Collector Wind Farm: Proposed Modifications.

As discussed in our last newsletter, RATCH Australia ('RATCH') has continued to progress various refinements to the wind farm as we prepare for the construction phase. Following discussions with the NSW Department of Planning & Environment, we have concluded that we need a formal modification to the existing Project Approval. A number of minor changes are being proposed and we will go through a formal process with the Department to ensure that any potential impacts are comprehensively assessed by them and that all interested parties have an opportunity to consider the changes and comment.

Refinement of site layout

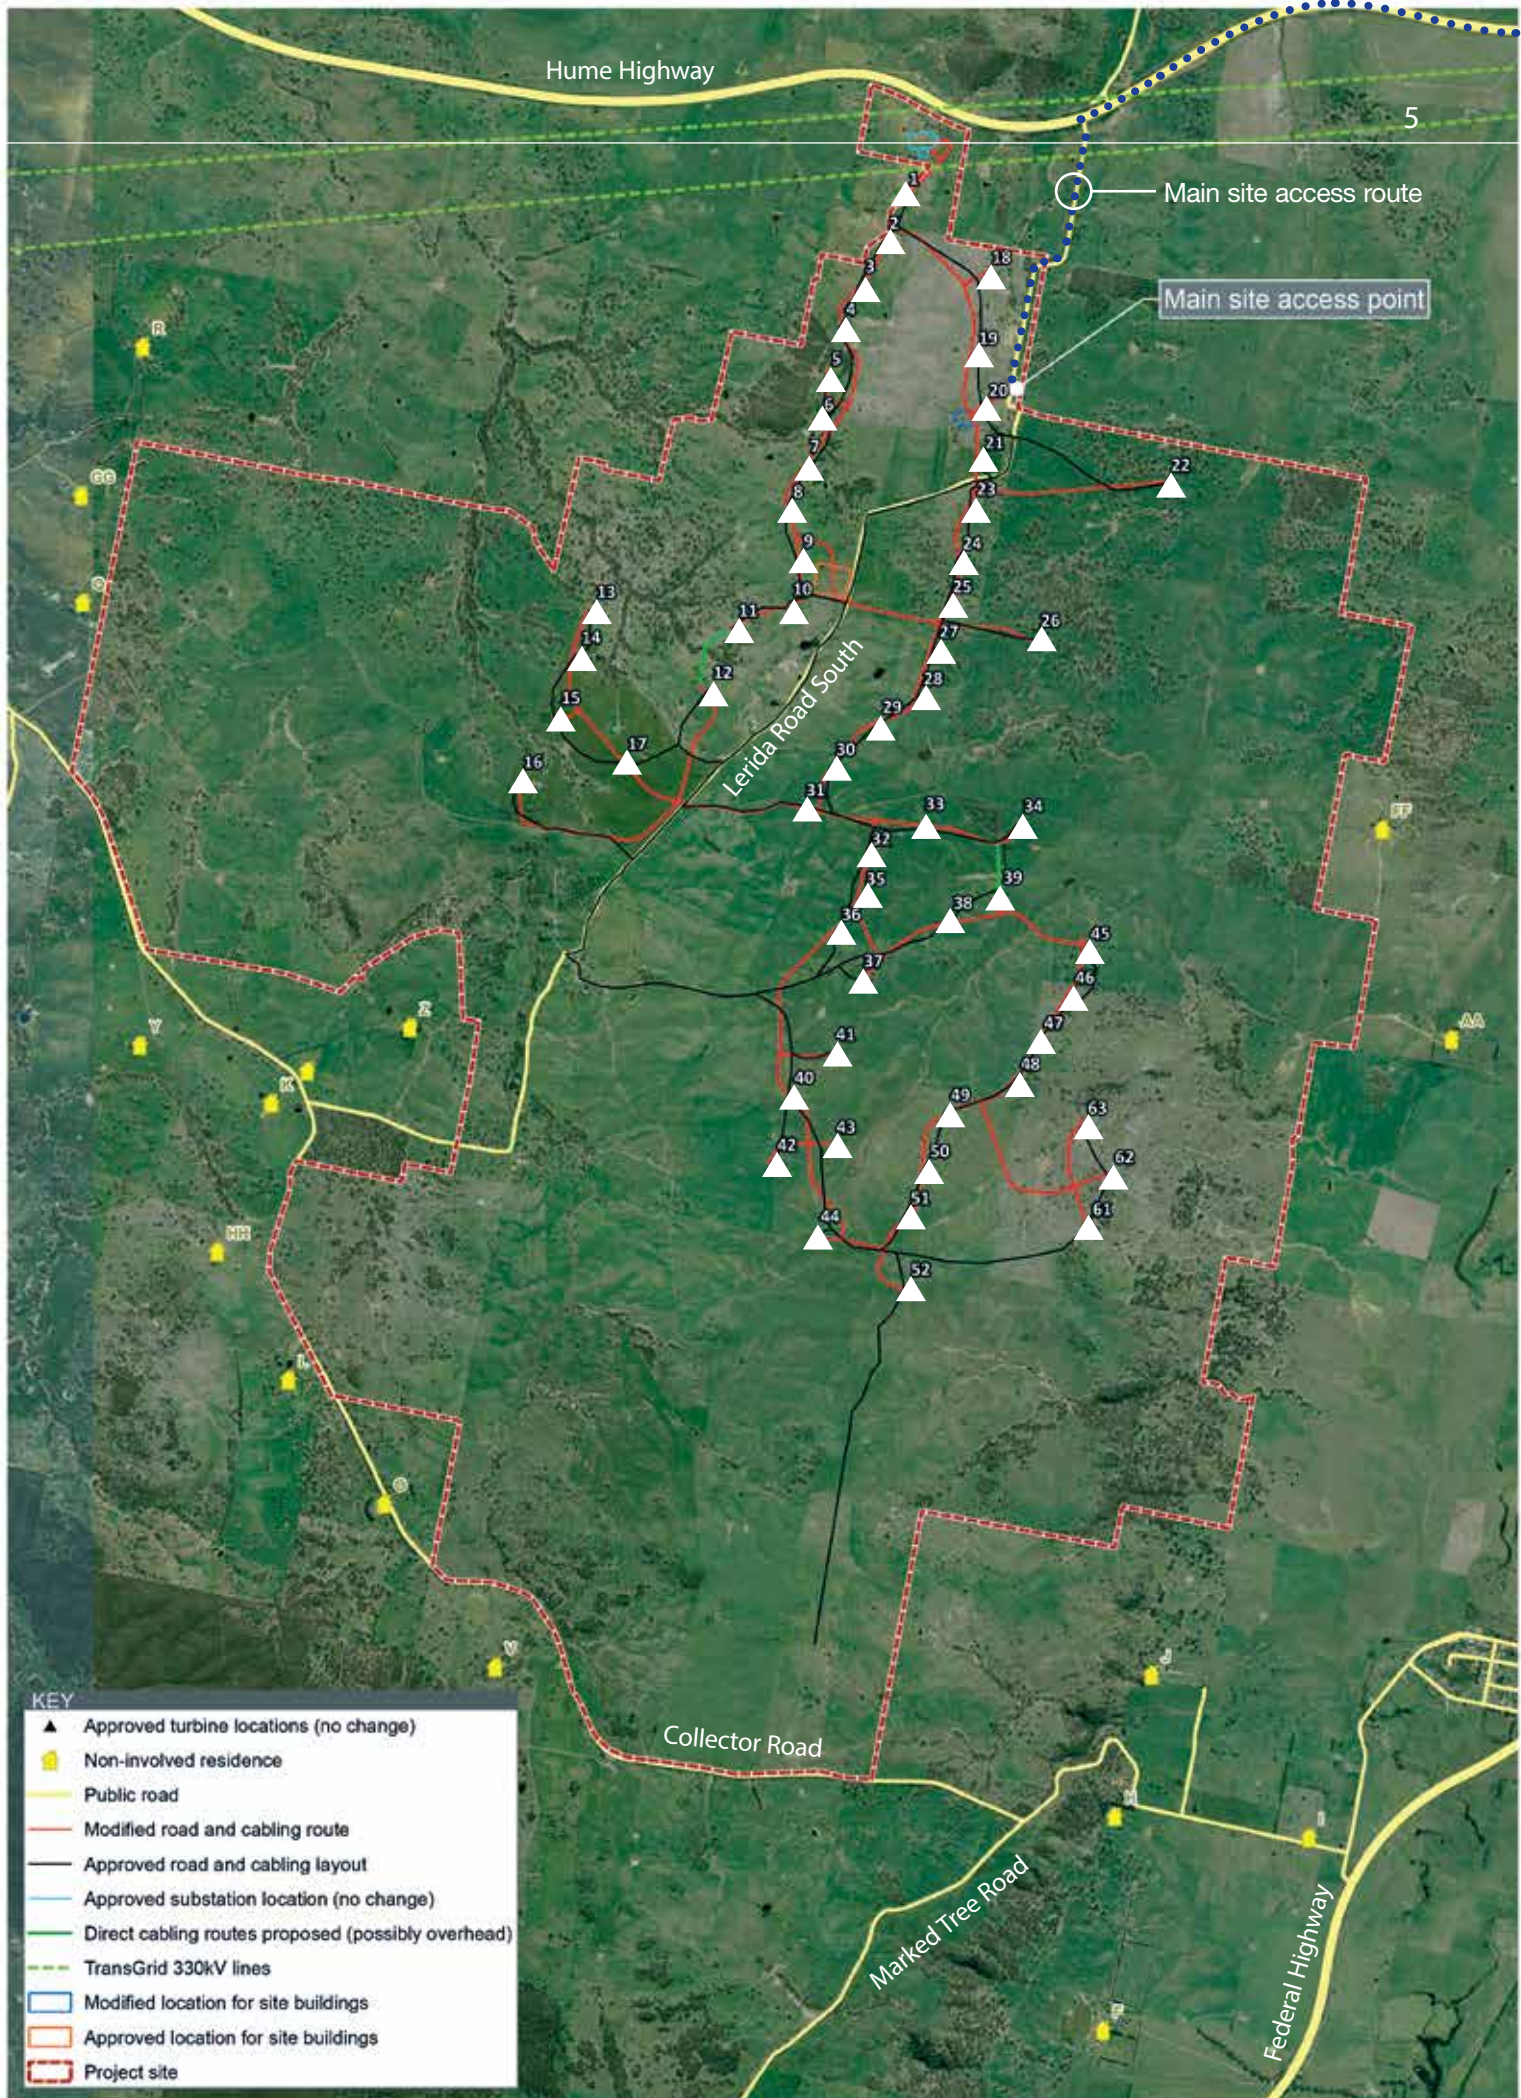
Changes to the on-site roads and cabling layout and location of the site buildings

The map on the following page shows the refinements that have been made to the site layout.

What has changed?	Why has this change been made?
The main site entry/exit point	The main site entry/exit point, where vehicles will access the site from Lerida Road South, has been moved approximately 2km north, closer to the Hume Highway.	To accommodate the requests of Upper Lachlan Shire Council. To improve road safety and minimise impacts on users of the public road.
On-site road layout	The location of some of the on-site roads has changed. In addition, there is one fewer intersection with Lerida Road South. In most instances, the refinement to the layout results in the site road moving by less than 100m from the previous location. The main site access route has not changed and will remain via the Hume Highway, with no construction traffic expected to pass through the Collector village or use the Collector – Gunning Road.	The proposed changes are a result of the changed site access point; and more detailed site engineering analyses that we have now carried out (such as detailed topographic data and the results of geo-technical investigations). To reduce the amount of earthworks needed and minimise the clearance of threatened native vegetation we have sought to minimise the need to build roads on steep hills. We have made changes to reduce the number of intersections between site roads and the public road (Lerida Road South), which improves road safety.

On-site cabling layout	The on-site cabling layout has changed in parallel with the road layout. As originally proposed, the majority of the cabling will be underground, however we are seeking the flexibility to have short direct links in two areas (rather than following the road), with the option for overhead cabling at these points.	We are seeking the option to utilise direct cable links in two specific locations (rather than following roads) because the direct link between two points will be much shorter, requiring less cabling and involving less ground disturbance. The option for overhead cabling is due to the nature of the ground in these two areas. This cabling will look similar to the overhead cabling that currently runs down Lerida Rd South (or down many suburban streets). Neither section is located near any houses. One section is located approximately 600m from the public road, the other is located more than 2km from the public road.

Revision of the area of vegetation impacted by our project	Given the changes to the road and cabling network, we anticipate that we will need to clear a larger area of vegetation around the site than previously proposed. We will still be offsetting all of the area impacted, and our “biodiversity offset area” will be increased in size to reflect these changes.	Changes to the road network have increased the length of site roads needed, hence the greater area of vegetation to be cleared for construction. Our revised design is aimed at minimising the areas of threatened native vegetation to be cleared, with the increased clearing undertaken in less ecologically-significant habitats. We have identified more than enough equivalent areas of land to offset this clearing within the committed biodiversity offset area.
